**TOWN OF MOUNTAIN VILLAGE
REGULAR DESIGN REVIEW BOARD MEETING
AGENDA**

THURSDAY OCTOBER 1, 2020 10:00 AM

TO: Mountain Village Design Review Board
FROM: John Miller, Senior Planner
FOR: Design Review Board Public Hearing; October 1, 2020
DATE: July 23, 2020, *Updated September 18, 2020*
RE: Staff Memo – Final Architecture Review, Lot 630

1 LOWER LEVEL LIGHTING PLAN
SCALE: 1/8" = 1'-0"

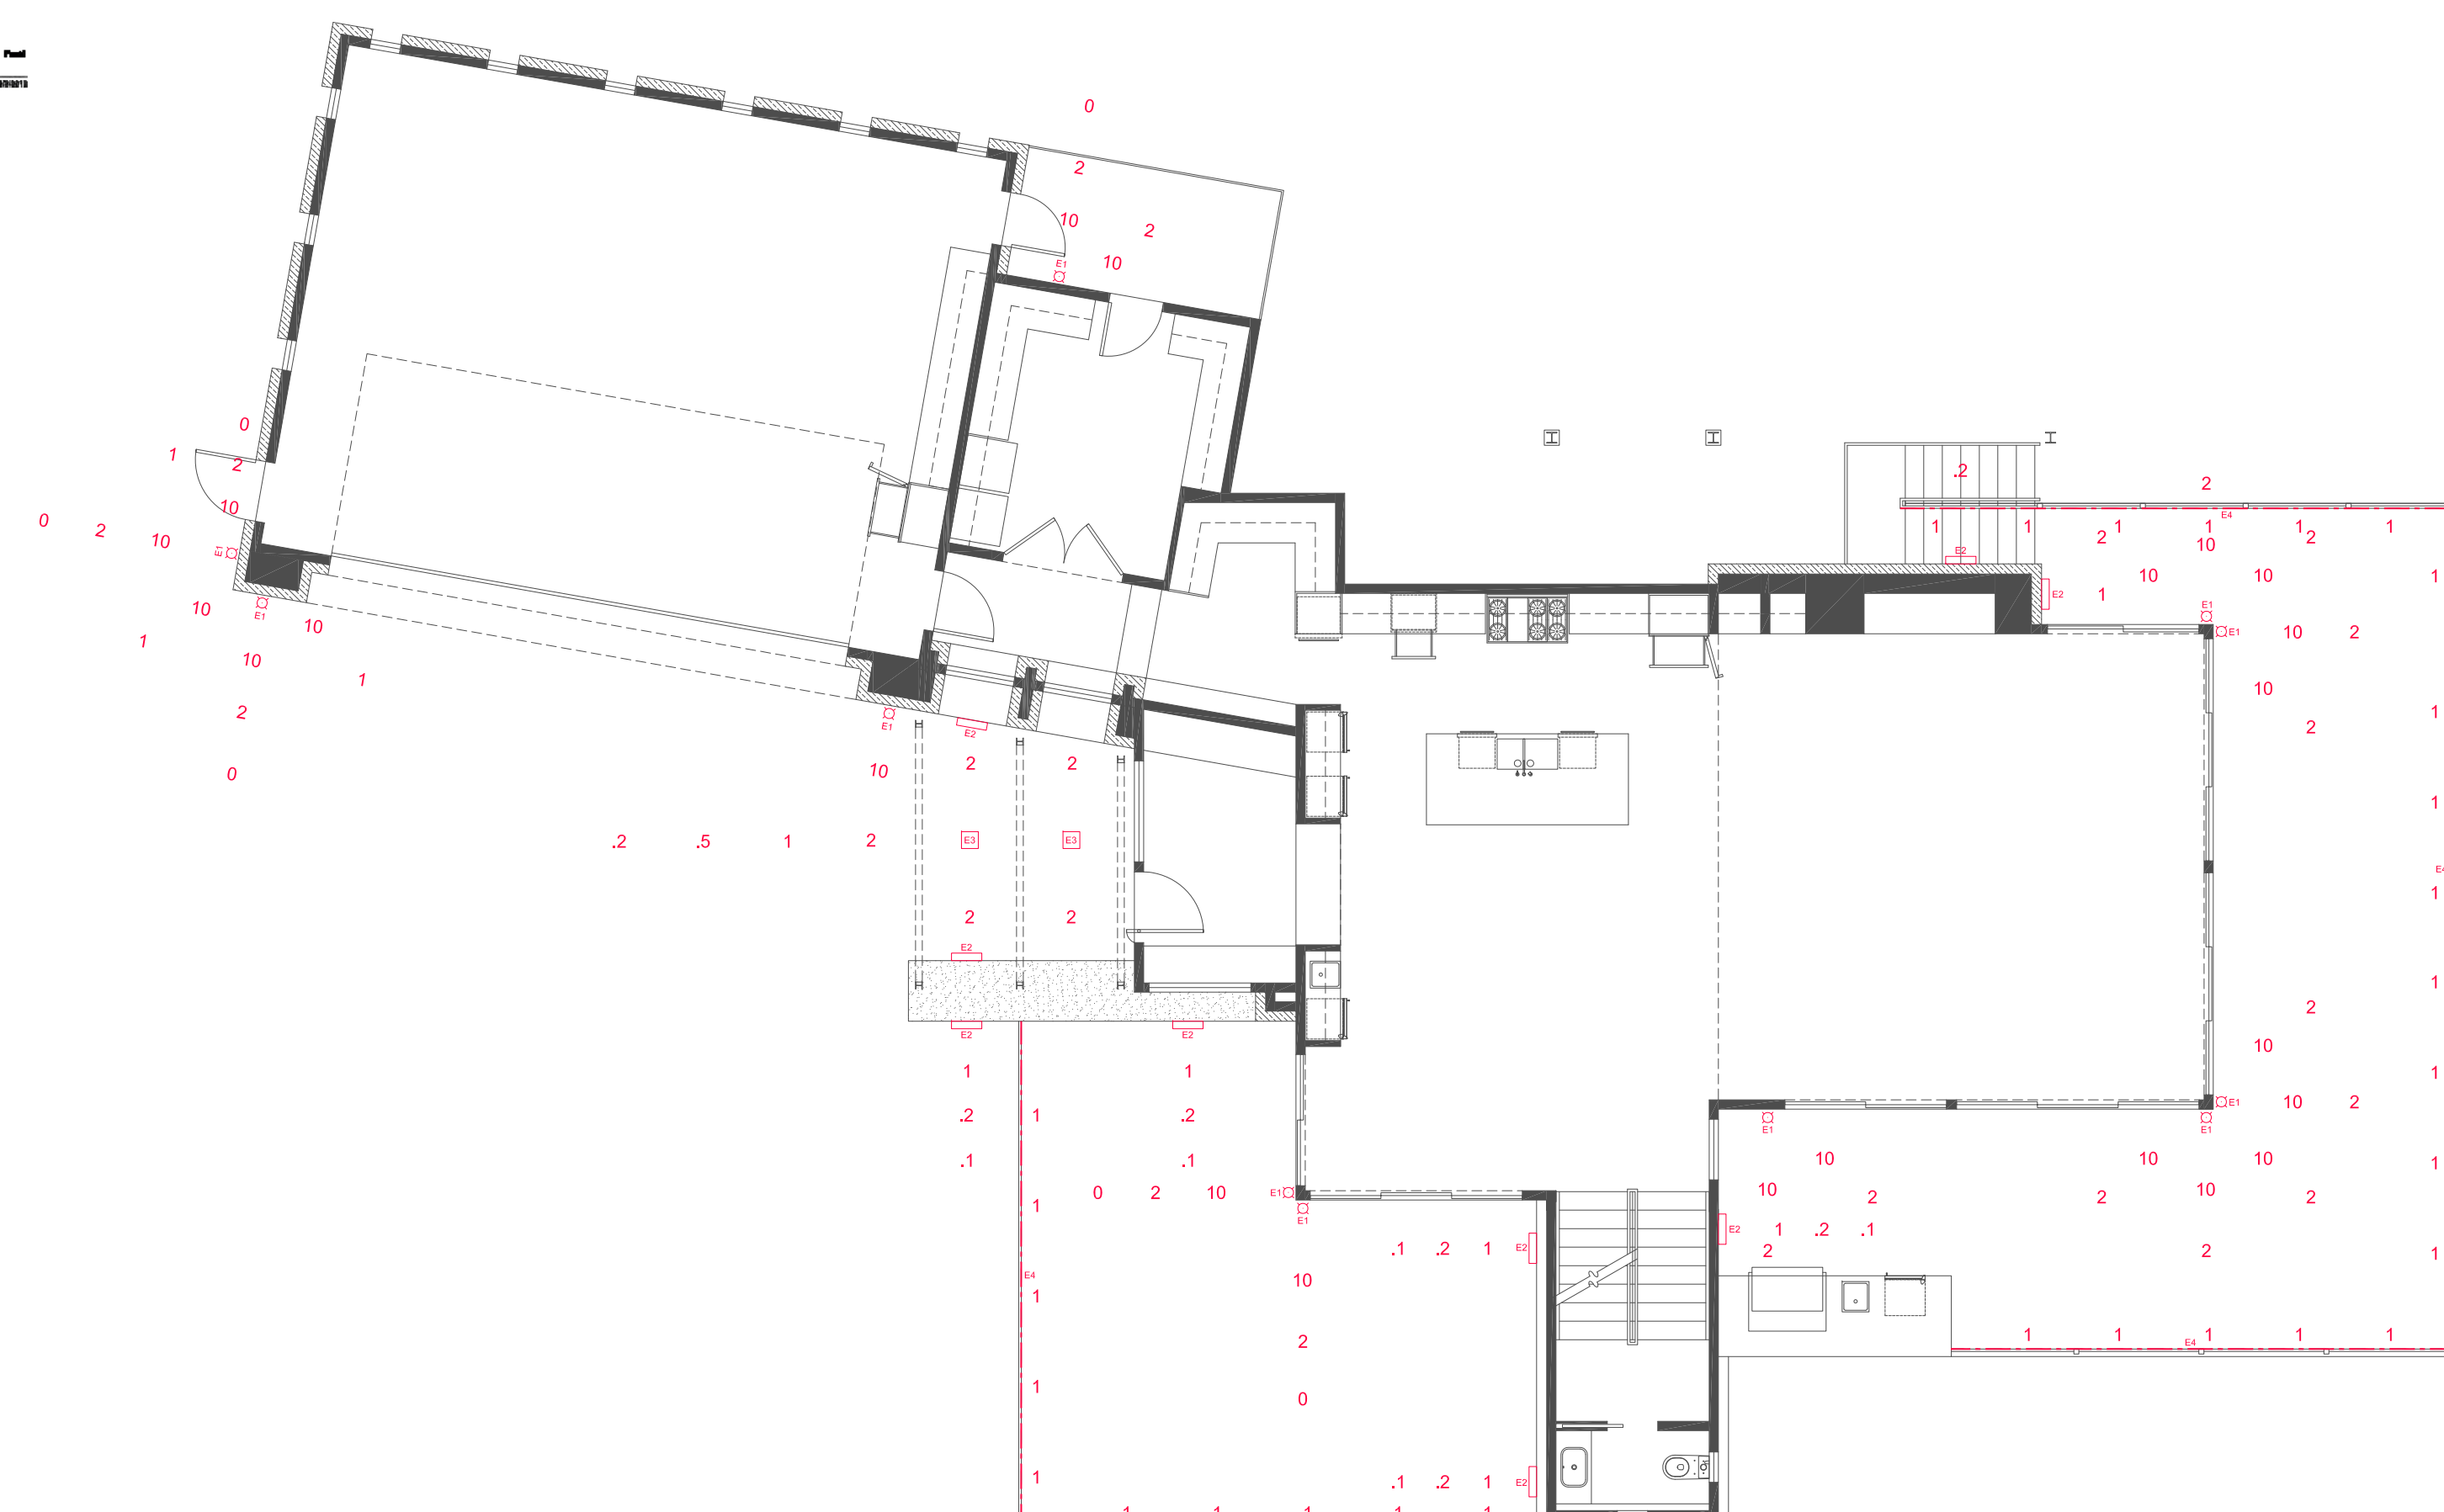
Staff: The applicant has provided an updated lighting plan since the September IASR reducing the overall number of fixtures requested. They have additionally provided additional information including specific cutsheets as well as a foot-candle study. Based

on the updated plans, the DRB may still want to request additional lighting changes that would subdue the lighting of the home. Two of the fixtures exceed the total lumens per lamp permitted. This would require either a dimmer to operate these fixtures permanently or a revision to the proposed fixtures. Staff suggests that the DRB condition a final lighting plan to be approved by staff and a member of the DRB to address total lighting levels, fixtures, and dimming options.

- 1) Prior to the issuance of a building permit, the address monument must be revised to demonstrate dry stack rock arrangement to match the home.
- 2) Prior to the issuance of a building permit, the applicant shall provide an updated lighting plan to be reviewed and approved by staff and a member of the DRB.

2 ADDRESS MONUMENT - FRONT
SCALE: 1" = 1'-0"

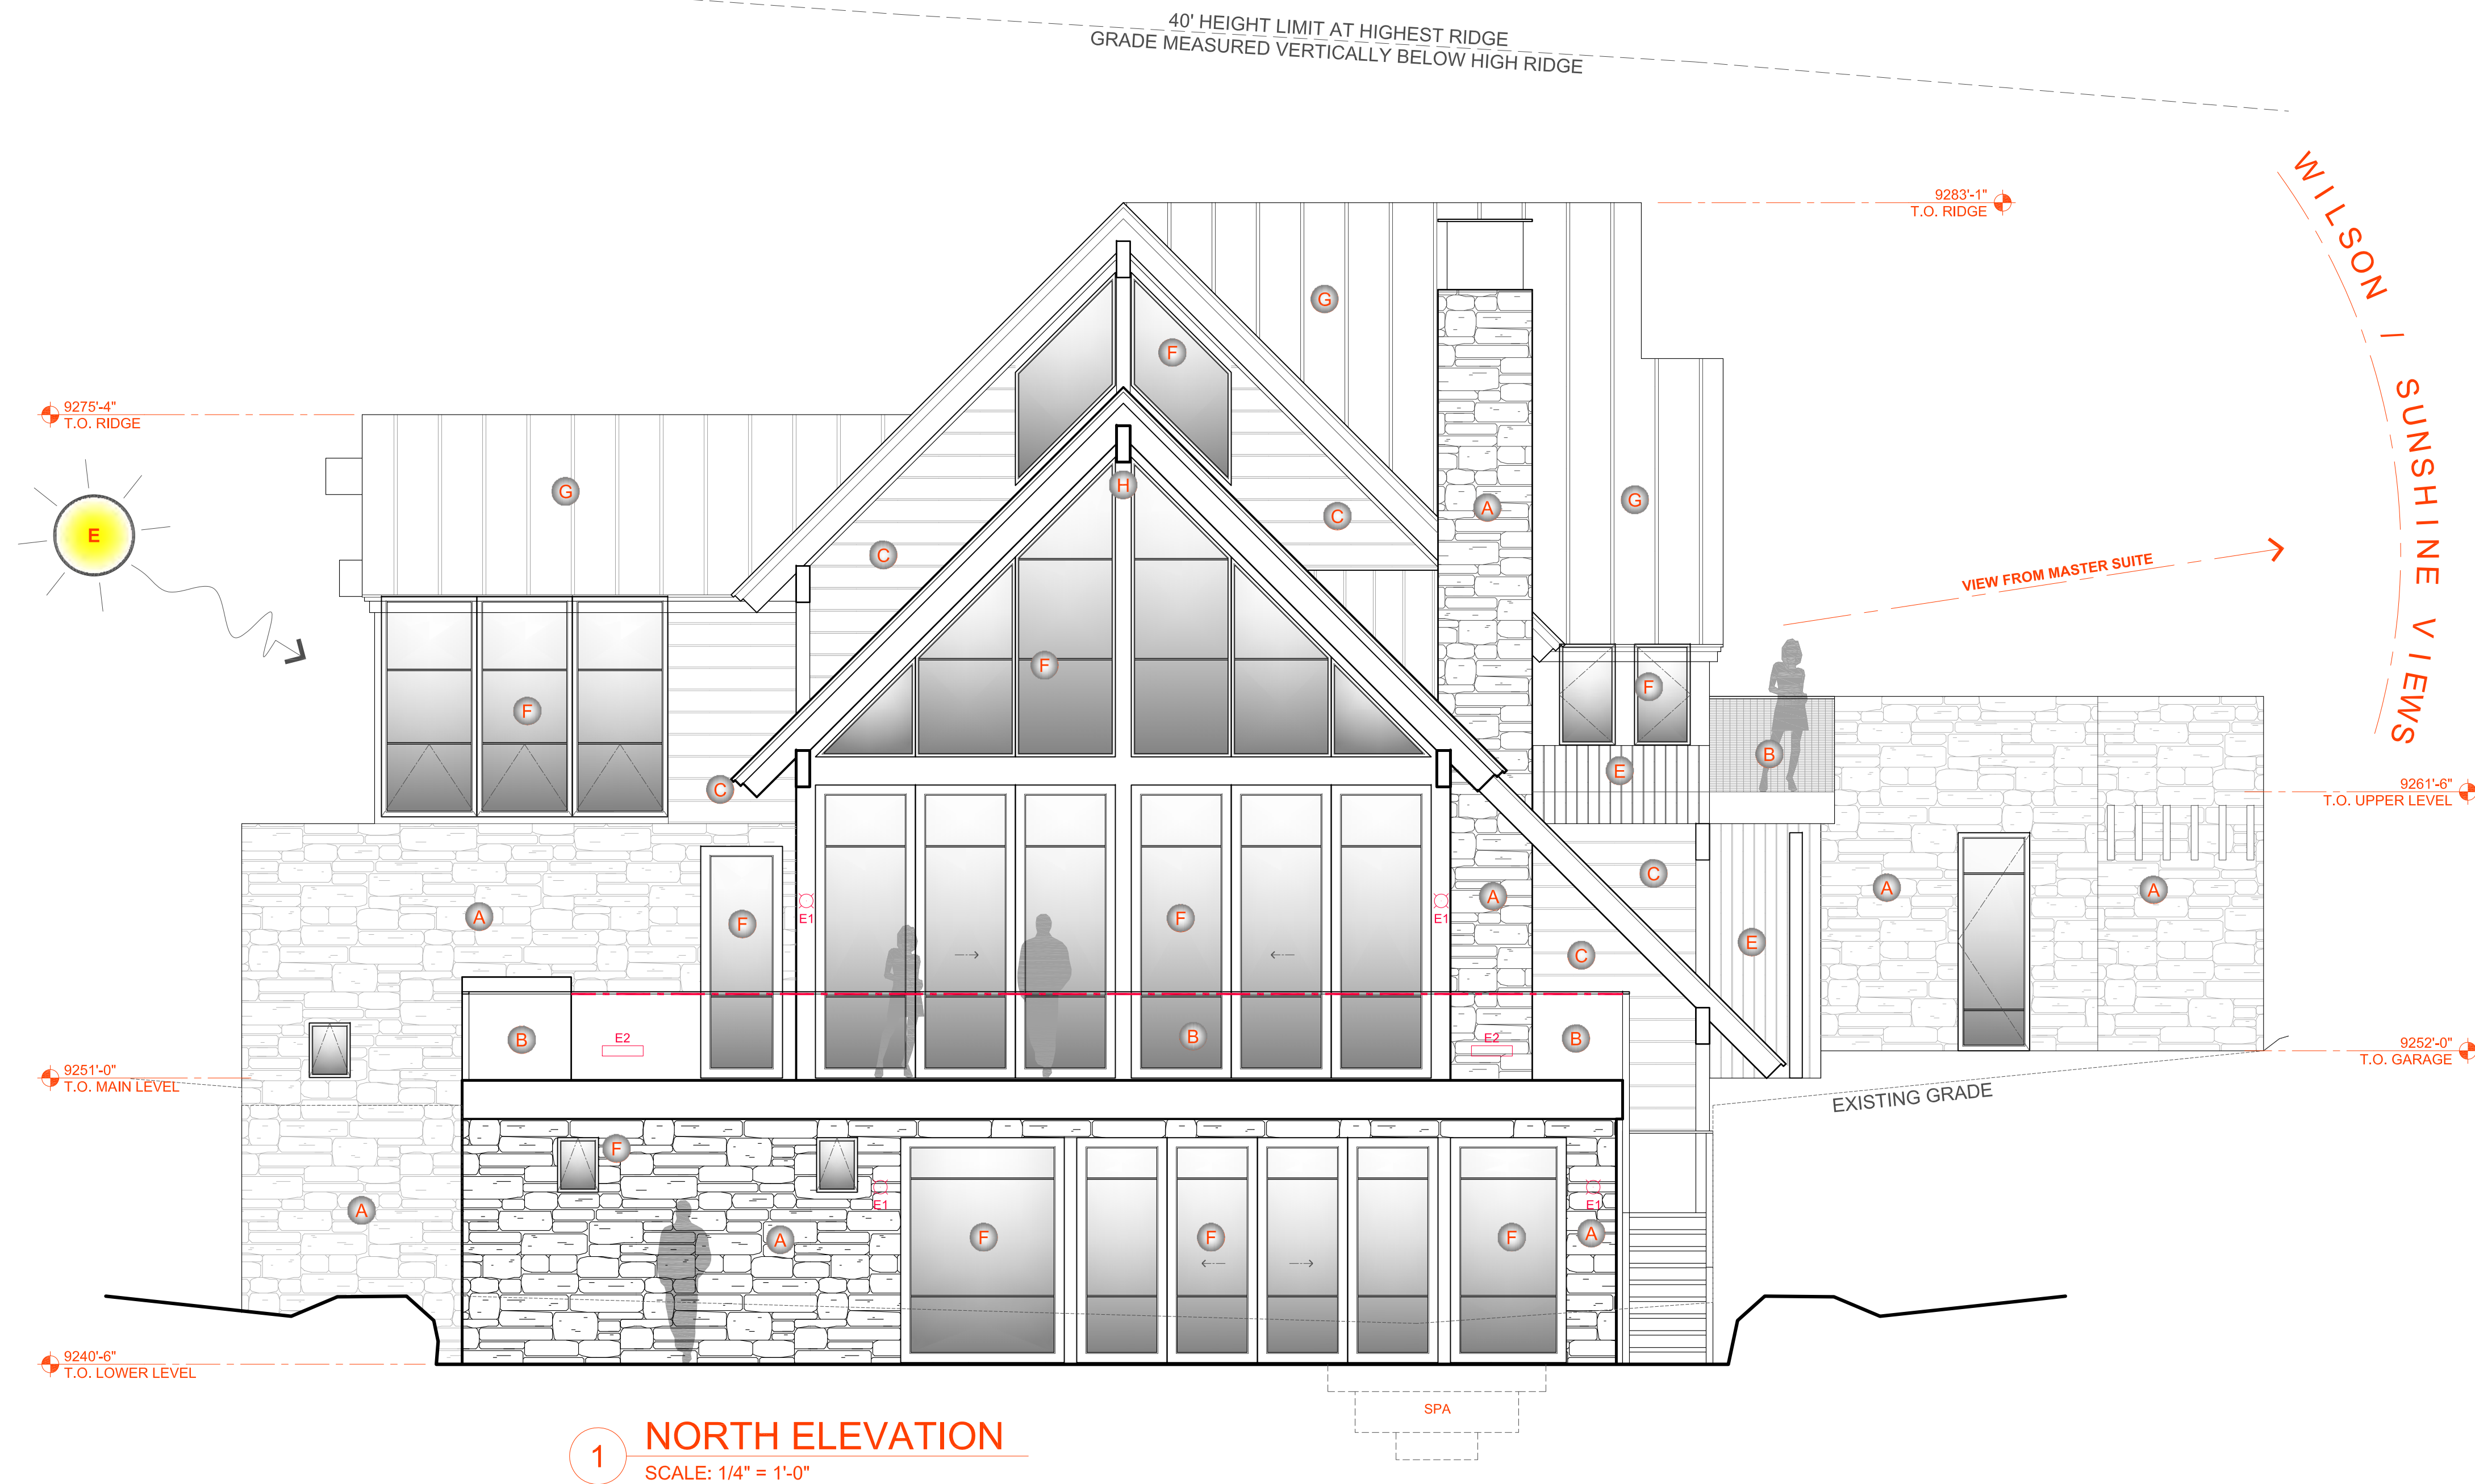
Staff: The address monument has been revised since the September hearing so that the numbering height now meets the 54" requirements of the CDC. Due to its location, it will require a General Easement Encroachment Agreement as discussed above. It should be noted that the address monument stone pattern does not appear to be a dry stack to match the home and this detail will need to be revised prior to issuance of a building permit so that the home and address monument stone is complimentary.
